Addendum to Discussion of Multidrop Access Methods

David D. Brandt
Rockwell Automation

Purpose

Successful TX after collisions

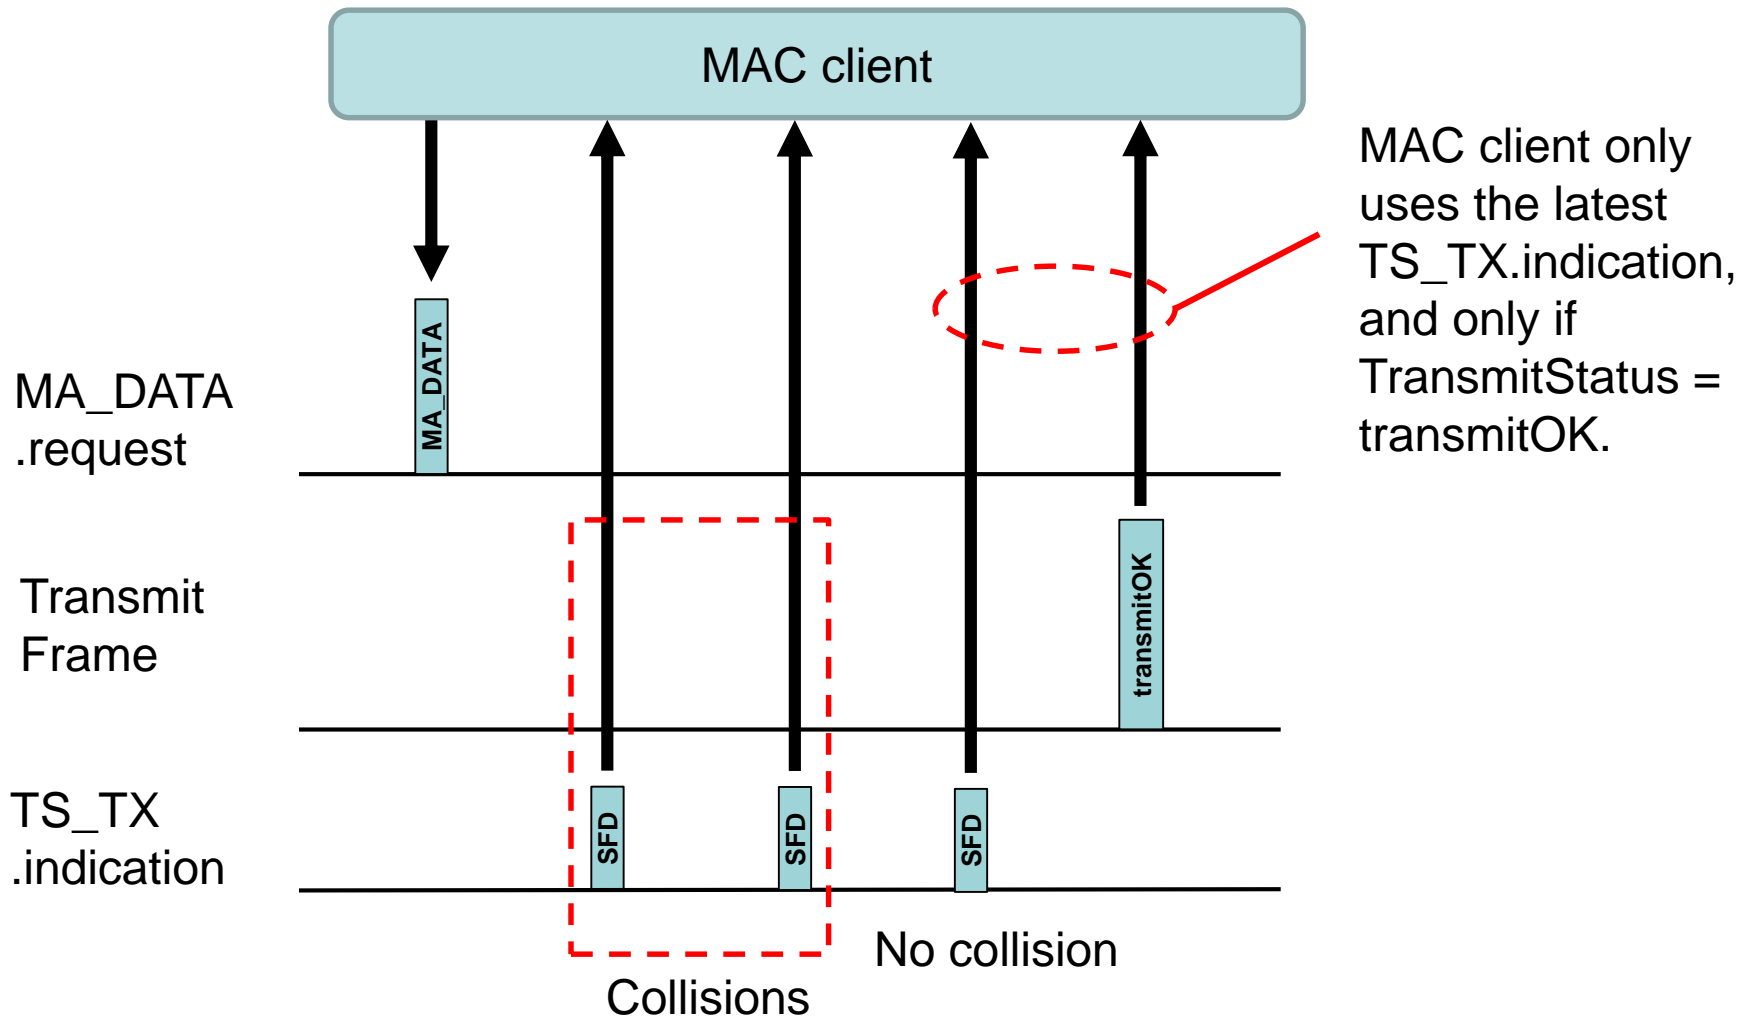
MAC client only uses the latest TS_TX.indication, and only if TransmitStatus = transmitOK.

Successful RX after collisions

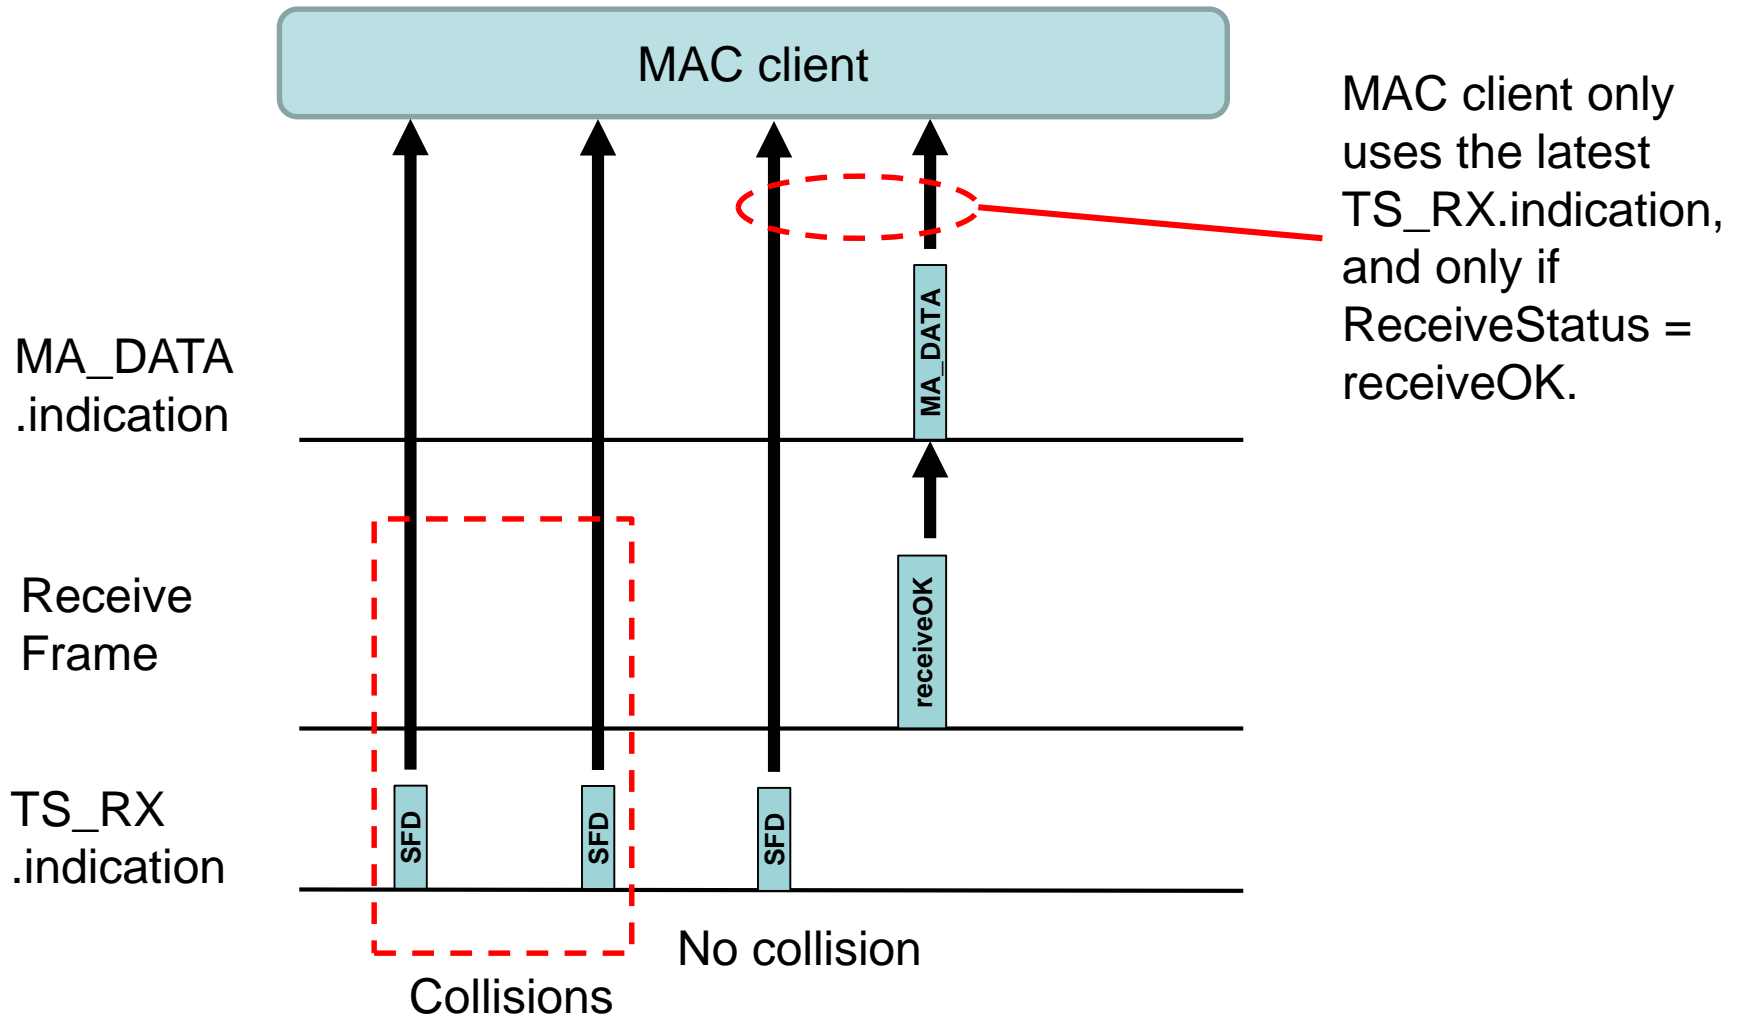
ReceiveFrame does not complete during collision due to short frame.
